## **BID ADDENDUM NO. 6**

### **Johnson Student Center**

### **Building Demolition, Increment 1 (Demolition) and Increment 2**

RANCHO SANTIAGO COMMUNITY COLLEGE DISTRICT  
SANTA ANA, CA

SECTION 2/A6.13

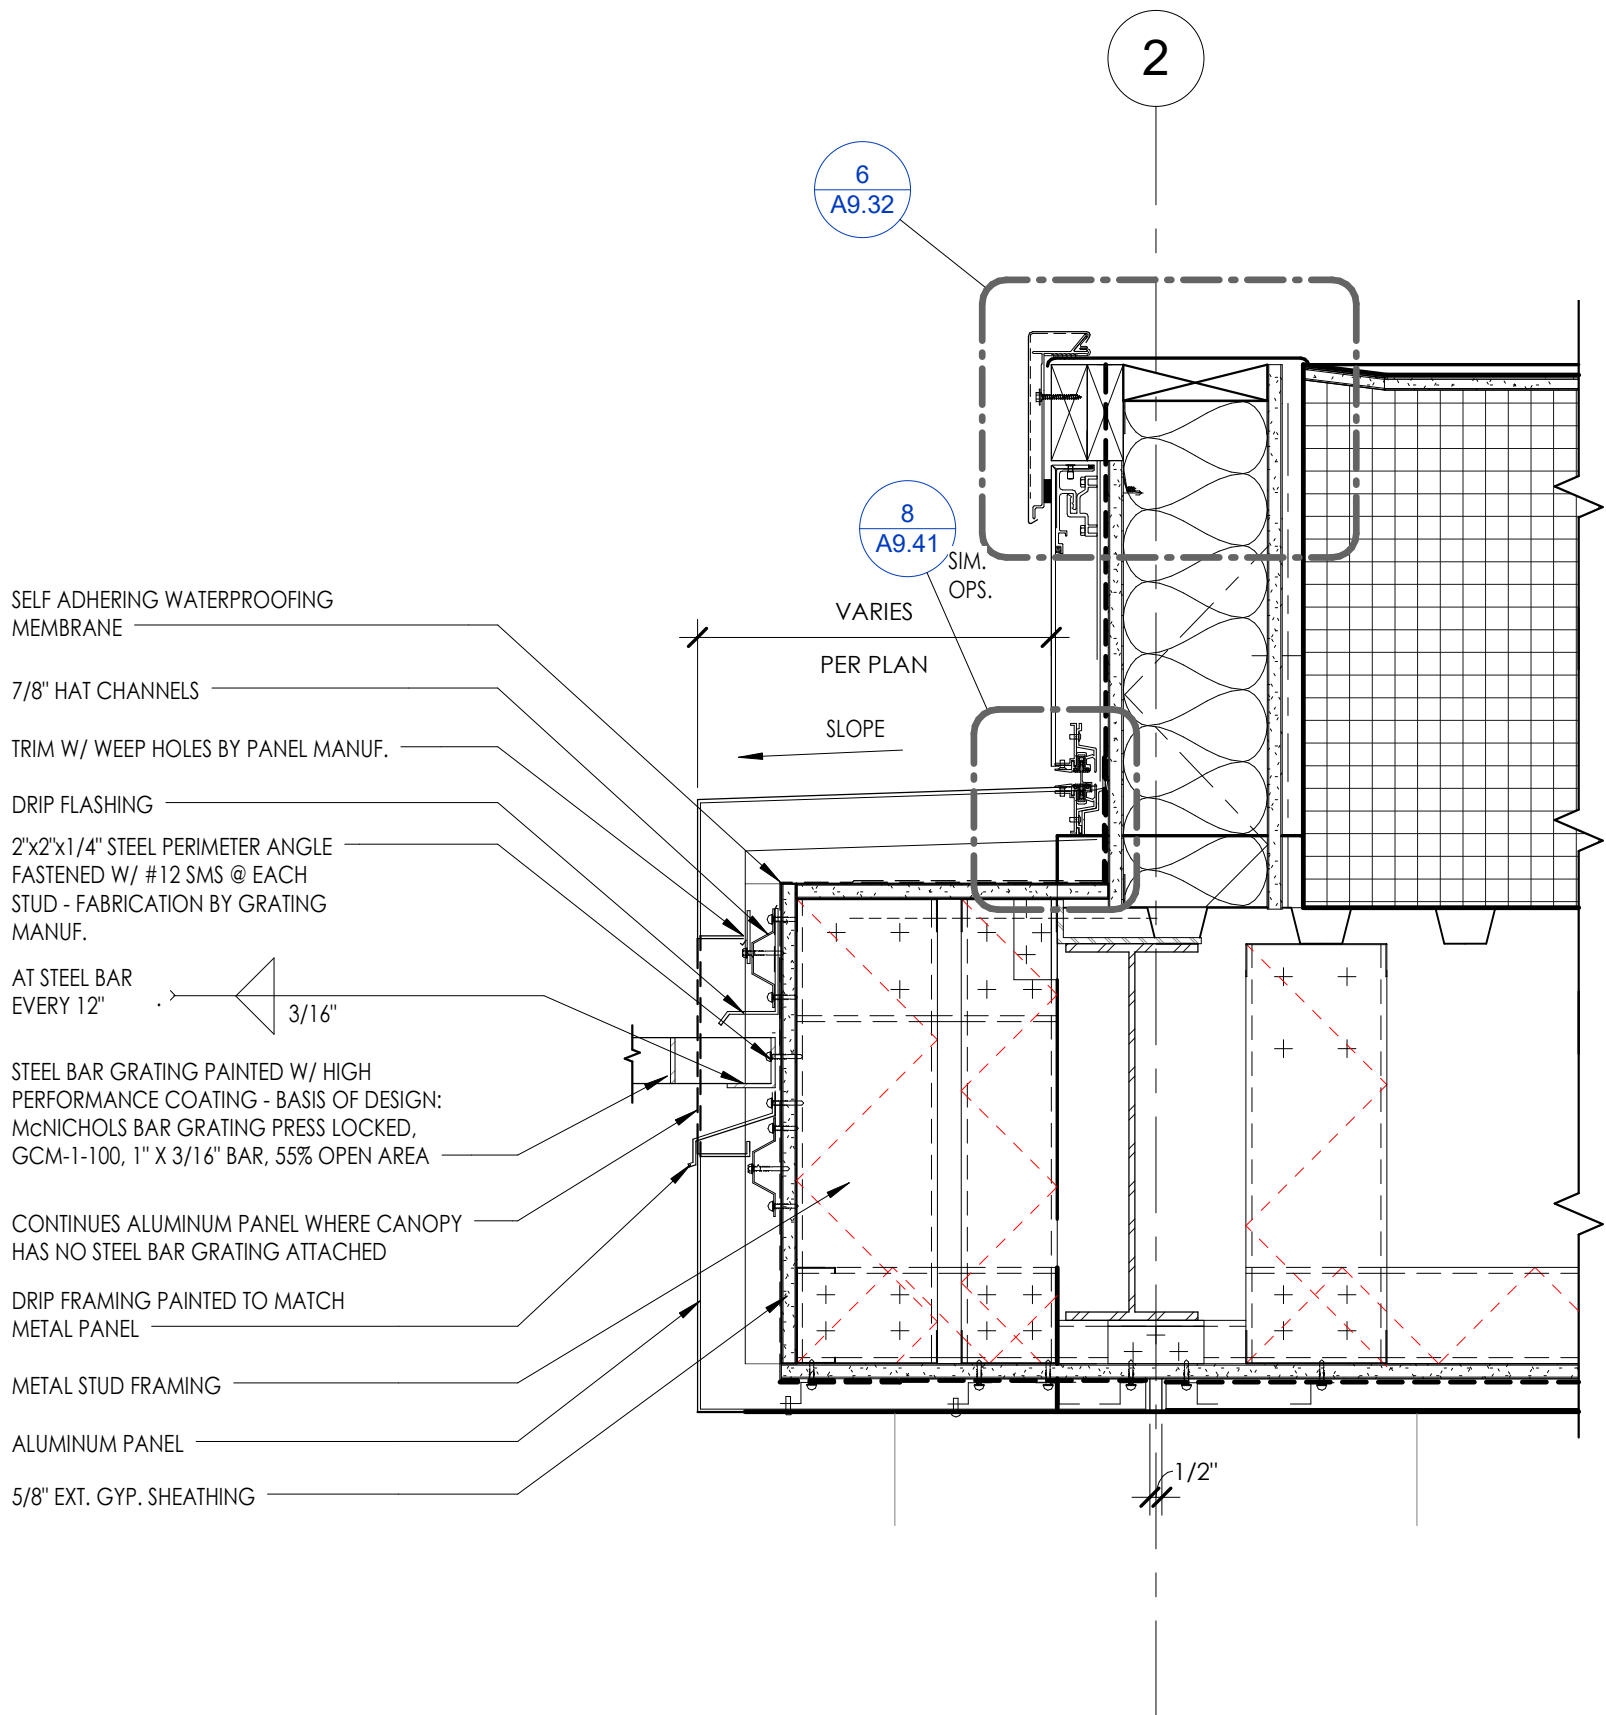
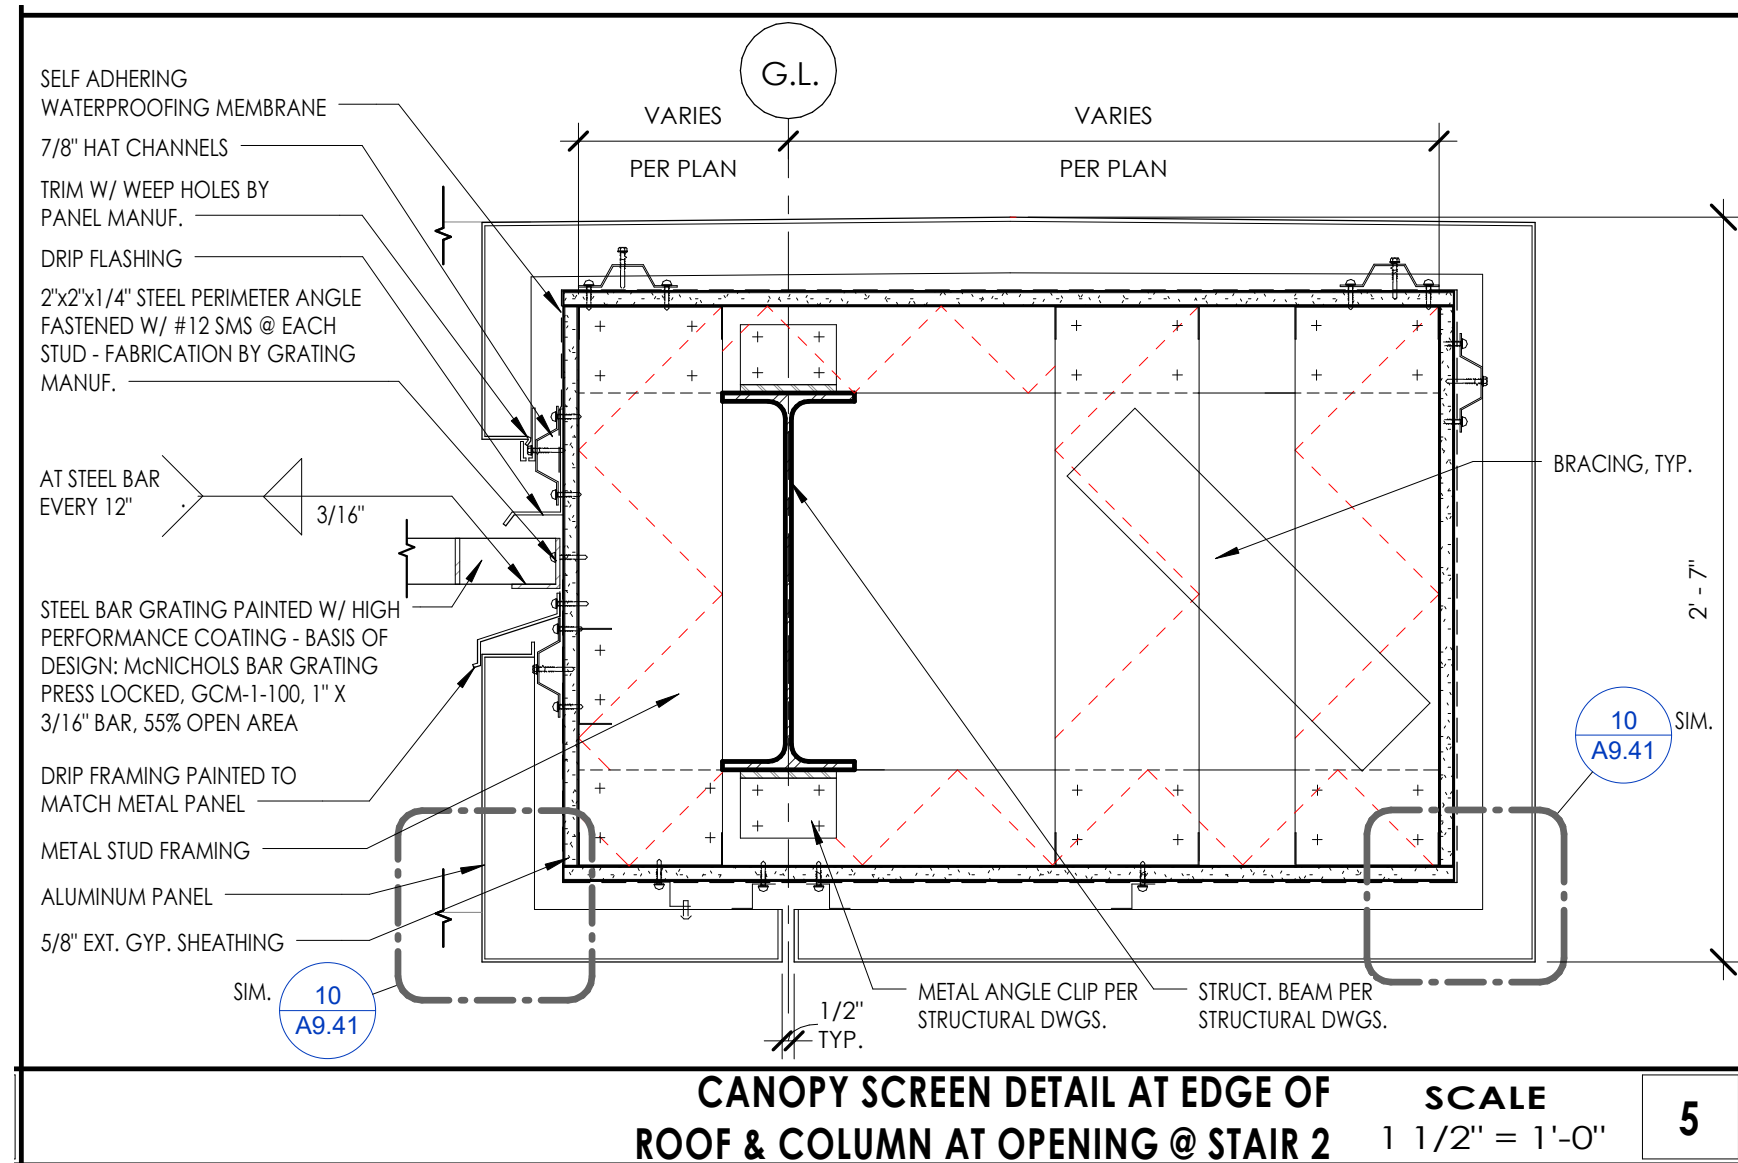
Increment #2 - Sheet A2.30, just north of Gridlines "2" between Gridlines "C" and "D" there appears to be a roof parapet at 32'-4 1/2", however 1/A5.02 takes you to 3/A5.11 which then takes you to 2/A9.32 and there are no details for this parapet. See attached for reference. Please review and advise.

FOR THE CANOPY WITH ROOF PARAPET, SEE ATTACHED REVISED DETAIL 2/A9.32. FOR THE CANOPY WITHOUT PARAPET SEE ATTACHED REVISED DETAILS 5/A9.32. FOR ALL OTHER DETAILS AND SECTIONS SEE ENLARGED ROOF PLAN 15/A6.12. ATTACHED DETAILS, SECTIONS AND PLANS ARE REVISED OTHERWISE USE THE DSA APPROVED SET. DIMENSIONS PROVIDED ON ENLARGED ROOF PLAN FOR MORE CLARIFICATION.

**DETAIL 4/A9.70**

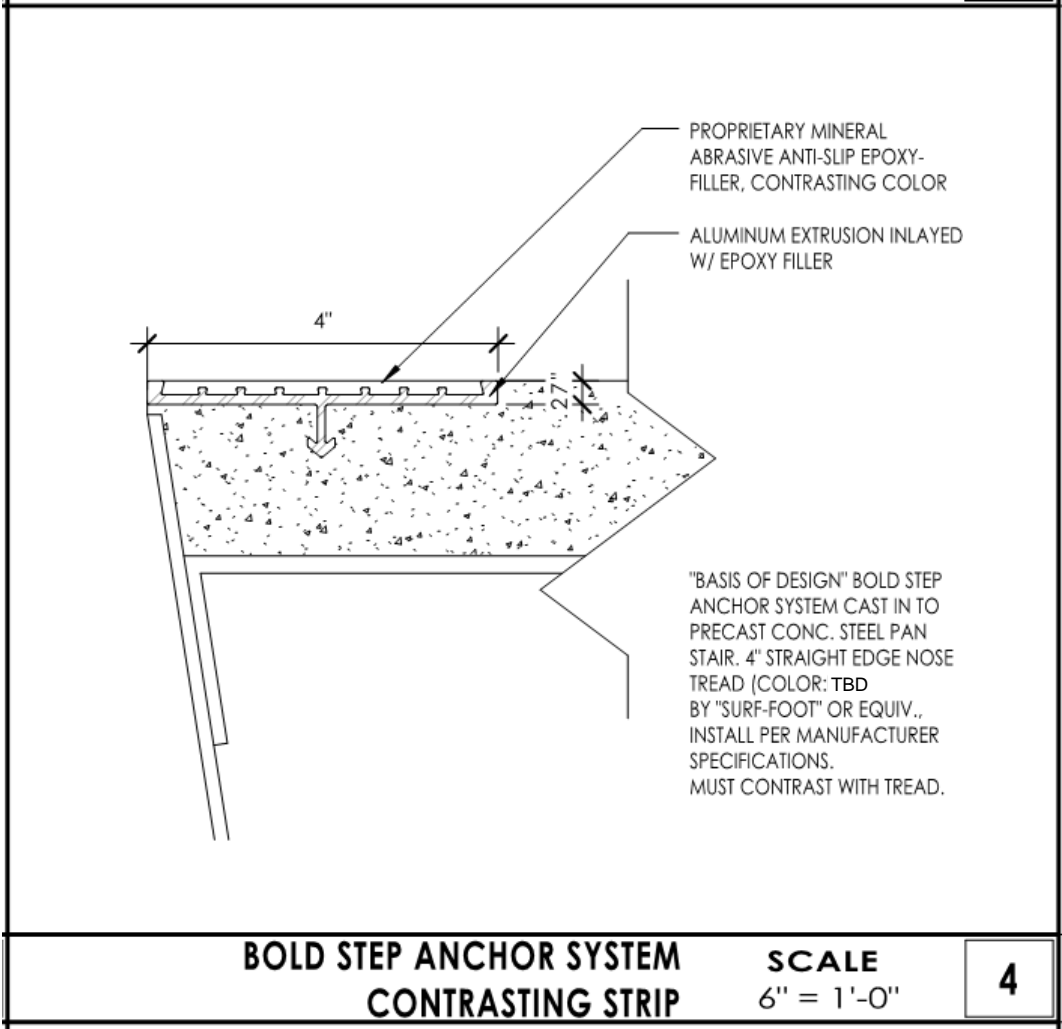
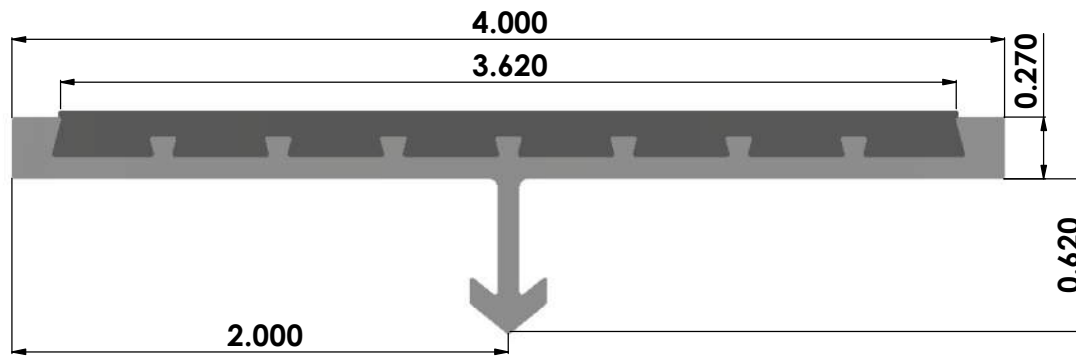
Increment #2 - Detail 4/A9.70 shows a 2" contrasting stripe on stair nosings for top and bottom treads at landings. In this detail it appears that the stripe adds thickness to the tread system, implying it is not simply paint (see attached markup). Specification section 05 50 00 1.5.B.2 provides more information on this stripping however no product or manufacturer is specified. This section does note "A painted stripe shall be acceptable". Please clarify if this stripe should either be applied paint or a prefabricated product. If a pre-fabricated stripe is desired please provide a specification.
